Subject: Workshop Data Responses Set 1
GWF Tracy Combined Cycle Power Plant Project (08-AFC-7)

APPLICATION FOR CERTIFICATION
FOR THE *GWF TRACY COMBINED CYCLE*
POWER PLANT PROJECT

**Workshop Informal
Data Request Set 1**

(08-AFC-7)

FIGURE WS1-2B
TRANSMISSION LINE SEGMENT 2
RECONDUCTORING NORTH
DISTURBANCE AREA
GWF TRACY COMBINED CYCLE
POWER PLANT PROJECT
SAN JOAQUIN COUNTY, CA

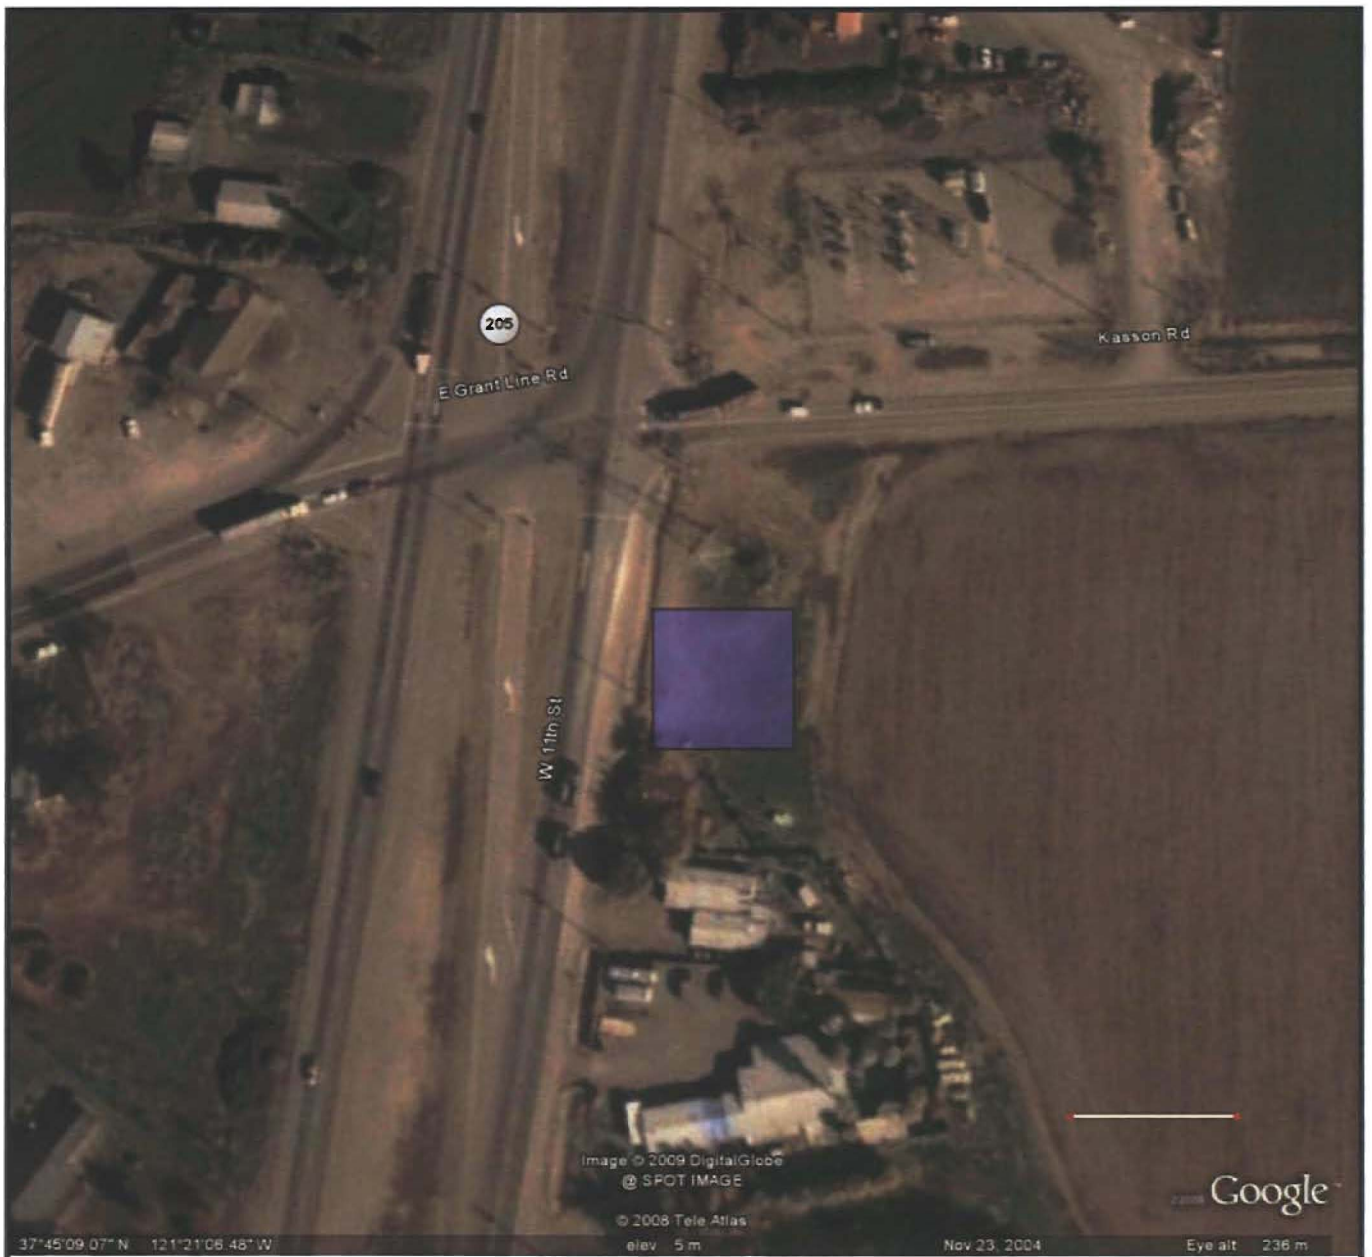
1. Provide the number of acres disturbed (temporary and permanent) for the 2 transmission termination structures (for GWF Tracy interconnection), relocated onsite equipment storage area (if not included in the 3.28 acre permanent disturbance area), and the construction areas for the reconductored transmission line segments. Provide map of the expected construction areas for the transmission line reconductoring segments and confirm that there is no active agricultural production in areas.

Pacific Gas and Electric Company (PG&E) estimates that a total of six reconductoring disturbance sites will be required, with each measuring approximately 100 feet by 100 feet (this communication is submitted at Attachment WS1-1). Based on PG&E's estimate, the total area of disturbance for reconductoring would be 1.37 acres. In reviewing this information, GWF was concerned that the reconductoring segments were not completely straight and was concerned that the estimate of six pull sites may be an underestimate. Therefore, GWF has prepared Figures WS1-1 through WS1-3 showing what it believes is the maximum expected number and approximate location of the reconductoring construction areas. The total number of reconductoring sites is 11, with a total area of disturbance of approximately 110,000 square feet or 2.53 acres. As noted on Figure WS-2D, the GWF reconductoring construction site may impact existing agricultural operations.
